UNITED STATES PATENT AND TRADEMARK OFFICE

APPLICATION NO.	FILING DATE	FIRST NAMED INVENTOR	ATTORNEY DOCKET NO.	CONFIRMATION NO.
10/608,255	06/27/2003	Belgacem Haba	SIPI-P107	8350
30554	7590	09/02/2004	EXAMINER	
SHEMWELL GREGORY & COURTNEY LLP 4880 STEVENS CREEK BOULEVARD SUITE 201 SAN JOSE, CA 95129			ZARROLI, MICHAEL C	
			ART UNIT	PAPER NUMBER
			2839

Office Action Summary	Application No. 10/608,255	Applicant(s) HABA ET AL.	
	Examiner Michael C. Zarroli	Art Unit 2839

DETAILED ACTION

FIG. 12C

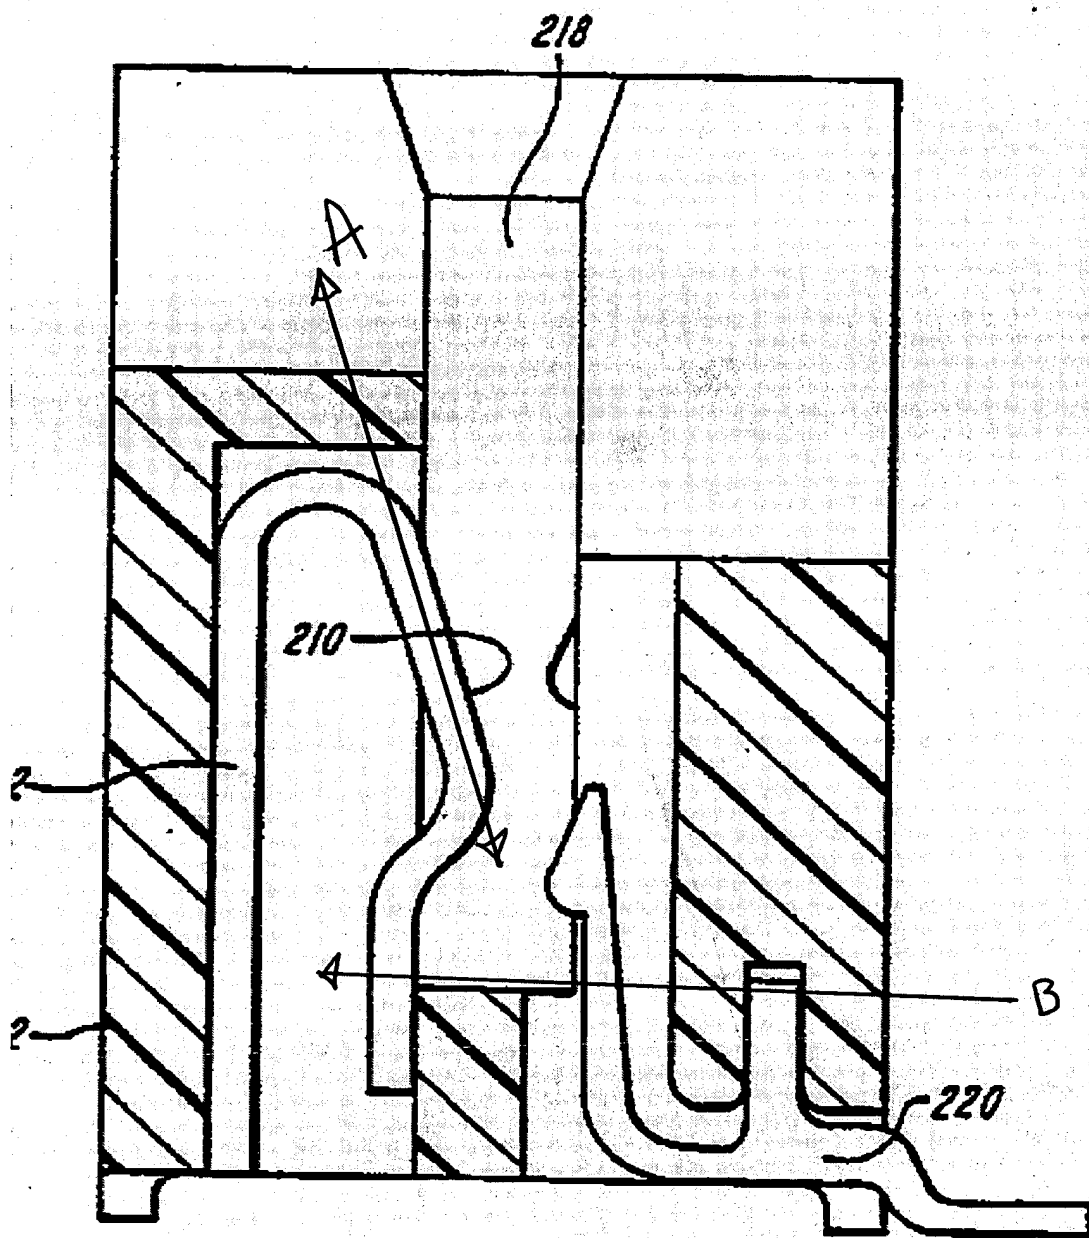
Regarding claims 4-5 and 10-11 Pickles discloses (see copy of fig. 12C from Pickles below) that before the insertion force is applied, the plurality of elements include a set of elements that have a first skewed orientation (arrow A below) with respect to a primary direction in which the insertion force is to be applied (218), and wherein the set of elements are aligned to increase in skew when affected by the insertion force and after the insertion force is applied (arrow B), the set of elements are biased to reduce in skew towards the first skewed orientation.

Regarding claim 9 Pickles discloses that the first interior surface and the second interior surface oppose one another across the cavity (fig. 12C).

Regarding claim 12 Pickles discloses that the member of each element in the plurality of elements is configured to have a bias towards becoming less skewed (vertical direction in fig. 12C as outlined in the 112 rejection above) after the

insertion force is applied (also vertical) and the mating component is inserted (fig. 10A), and wherein the bias (more towards vertical) coincides with the coupling structure pressing against the mating component (fig. 7).
